Road Hog⁴

Display- USB Cable Routing

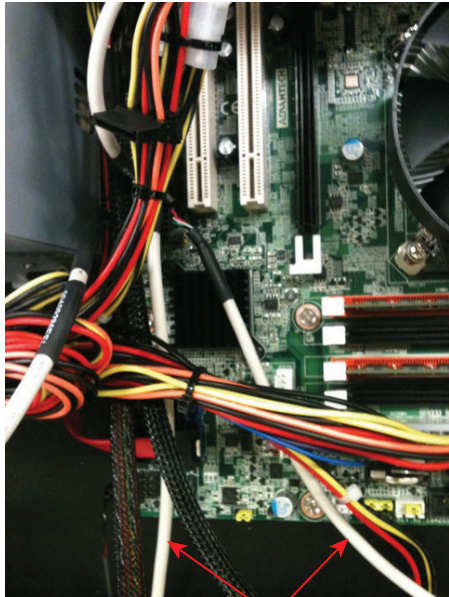
It was discovered on some Road Hog 4 consoles were assembled with the LCD display USB driver cables routed incorrectly and were causing the connections to come loose from the motherboard.

Incorrect Routing-

The USB cables are routed **OVER** the power supply cables.

Correct Routing-

The USB cables should be routed **UNDERNEATH** the power supply cables.
